**McLean's Mountain Wind Farm**

**Re: McLean's Mountain Wind Farm Project  
Renewable Energy Approval (REA) - Amendment**

*Modifications Document for  
REA Amendment - March 2013*

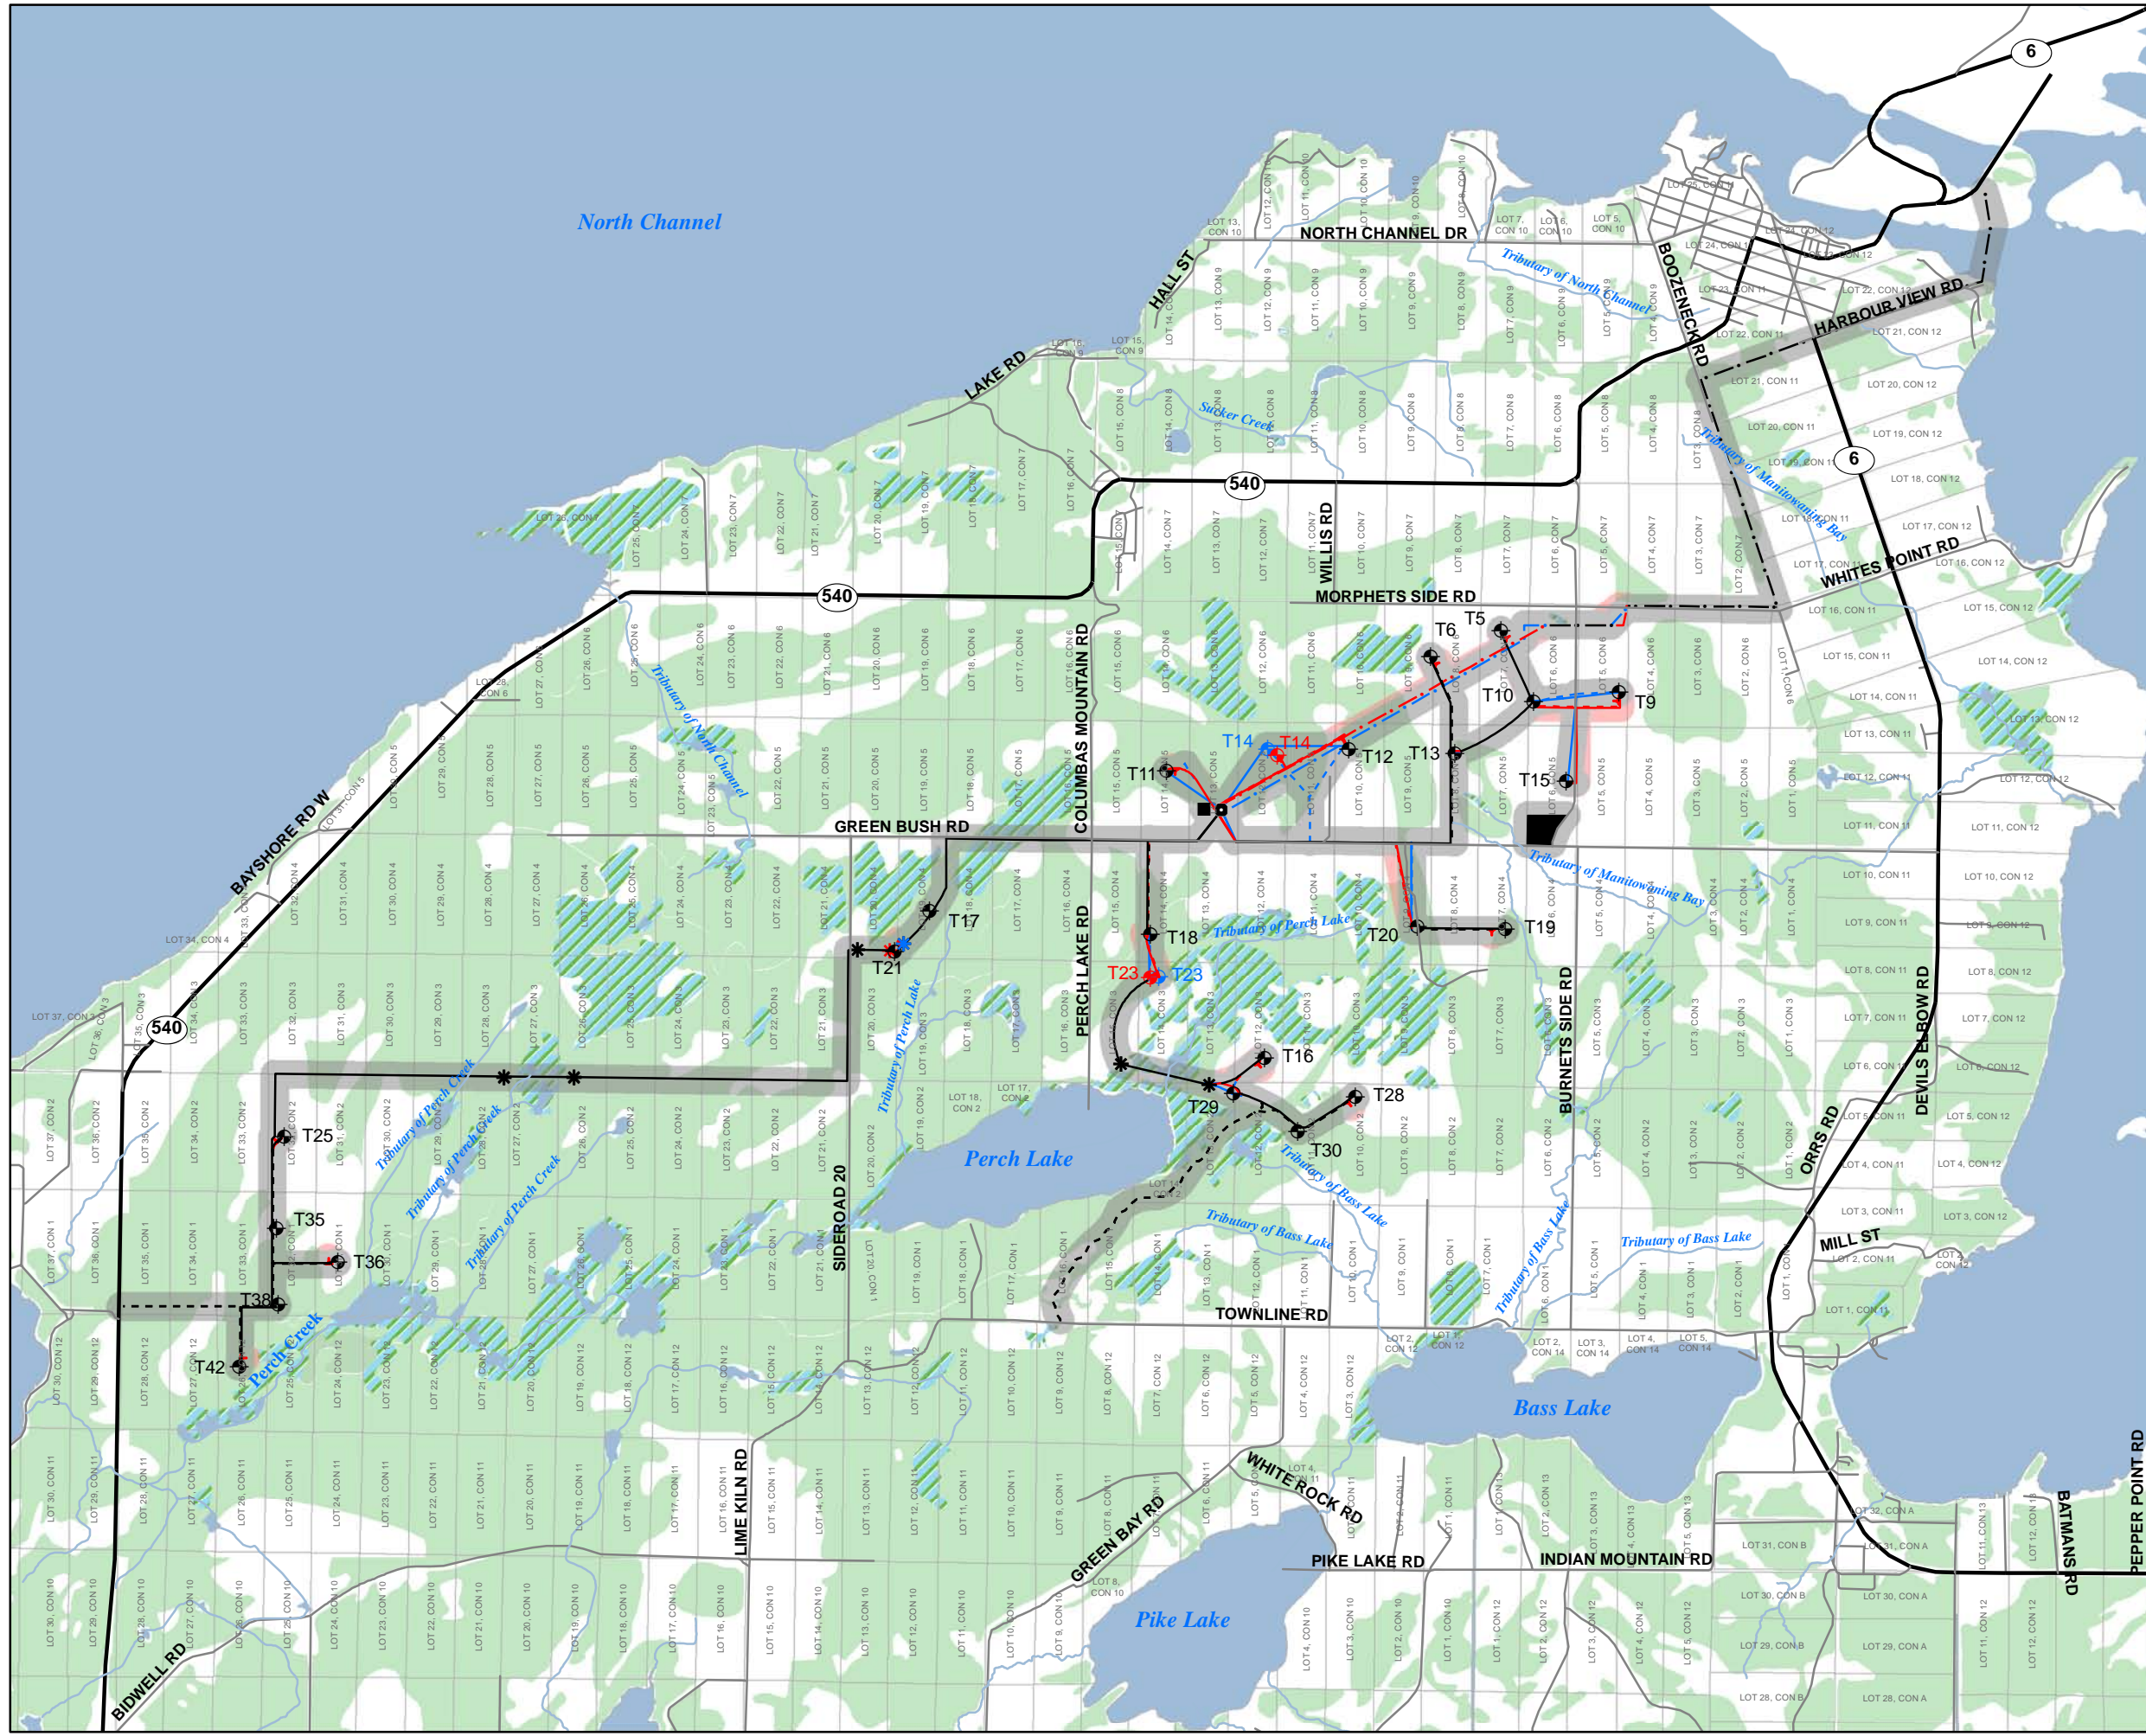
The proposed changes are identified in the attached **Figure**. The potential impacts these changes will have on natural features identified in the NHA are detailed in the **Table**, which is also attached. The proposed layout changes do not result in a meaningful change to the information presented in the Environmental Impact Study (Dillon Consulting Limited, September 2011) previously reviewed by the MNR. In some cases, layout changes will bring about a positive environmental effect due to reduced foot print in natural features, reduced need for clearing of vegetation and an increased distance from natural features. A small number of proposed changes will cause slight negative environmental impacts due to increases in size of project foot print. For the purposes of your review, we have included separately, figures forming part of the EIS, which incorporate the proposed changes to the project location.

4	Access Road and feeder line to turbine site T20 (and T19) coming in from Greenbush Road to be shifted approximately 125 m to the west.	To avoid topographic challenges for access road construction and access to turbine sites with construction equipment.	Currently, the access road to turbine site T20 occurs within Raptor Winter Feeding and Roosting Area 4, adjacent to Open Country Breeding Bird Habitat 4 and runs through a small section of non-significant Woodland. With the proposed change, this project component will remain on the edge of Raptor Wintering habitat and within non-significant Woodland.	McLean's Mountain Wind Farm Environmental Impact Study Report – Figures 4-11	McLean's Mountain Wind Farm Environmental Impact Study Report – Table 4, Table 6	Shifting the access road from Greenbush Road to turbine site T20 by 125 m to the west will move the access road to the edge of Raptor Winter Feeding and Roosting Area 4, and will move the access road further from the edge of Open Country Breeding Bird Habitat 4. The access road will remain within the woodland. No additional constraints are present within 120 m of the proposed change in location.  Neutral Impact.

5	Elimination of originally-planned access roads and adjustment of the feeder line from T12/T14 and the proposed project substation. Access Road connecting T12 and T14 to come directly from substation and more closely	In conjunction with the relocation of turbine T14 (see table row below), it is proposed to relocate the access roads and electrical feeder lines connecting to turbines T14 and T12. The original plan for the access road was to cut a single-	Currently, access roads to turbine sites T12 and T14 occur in Non-significant woodland. With the proposed changes, these project components will remain within this natural heritage feature and will not put project components within 120 m of any significant or sensitive features.	McLean's Mountain Wind Farm Environmental Impact Study Report – Figures 4-11	N/A	The proposed altering of the road to more closely follow the transmission line path and removing the "Y" junction in the access road will reduce the footprint in woodland habitat. No natural feature constraints are present within 120 m of the proposed change in location.  Positive Impact.

8	Path of feeder line to turbine site T11 from substation to be shifted to match access road and both have been rounded slightly to avoid a 90 degree turn.	To reduce total footprint and to remove the 90 degree angle to the turbine.	Currently, the access road and feeder line to turbine site T11 occur in Woodland that has been evaluated as non-significant. Proposed changes to these project components will remain within this natural heritage feature and will not put project components within 120 m of any significant or sensitive features.	McLean's Mountain Wind Farm Environmental Impact Study Report – Figures 4-11	N/A	The proposed rounding of the access road and relocation of the feeder line to turbine site T11 from the substation will have negligible impact on the footprint within the Woodland feature.  Neutral Impact.

<b>Addition of Thirteen (13) Truck Turnarounds (Hammerheads) (6 hammerheads require vegetation clearing and/or habitat disturbance as described below)</b>						
12	Hammerhead truck turnarounds to be added at turbine sites T5, T6 and T9.	It was always intended that truck turnaround areas would be required adjacent to the access roads, but until detailed design was completed the location of these turnaround areas (or hammerheads) was unknown. The project location figure now identifies the proposed location of the hammerheads, most of which are in areas that do not require vegetation	The proposed hammerheads at turbine sites T5, T6 and T9 are in Raptor Winter Feeding and Roosting Area 4 and Open Country Breeding Bird Habitat 4.	N/A	N/A	The addition of hammerhead truck turnarounds will require a small area of open country habitat to be removed adjacent to each turbine.  Slight Negative Impact.

13	Hammerhead truck turnaround to be added at south side of access road, east of turbine site T11.		The proposed turbine site T11 hammerhead occurs in Woodland that has been evaluated as non-significant and will not place a project component within 120 m of any new significant or sensitive features.	N/A	N/A	The addition of a hammerhead truck turnaround will require a small additional non-significant woodland area to be cleared.  Slight Negative Impact.
14	Addition of hammerhead truck turnaround on the west side of access road north of turbine site T21.		Wetland Unit 3/Woodland Amphibian Breeding Habitat 5/Turtle Overwintering Area 3 are approximately 130 metres from western edge of hammerhead.	N/A	N/A	The hammerhead truck turnaround area proposed on the west side of access road north of turbine site T21 is in an open non-significant woodland area. The hammerhead boundary is 130 m from Wetland Unit 3/Woodland Amphibian Breeding Habitat 5/Turtle Overwintering Area 3.  Slight Negative Impact.
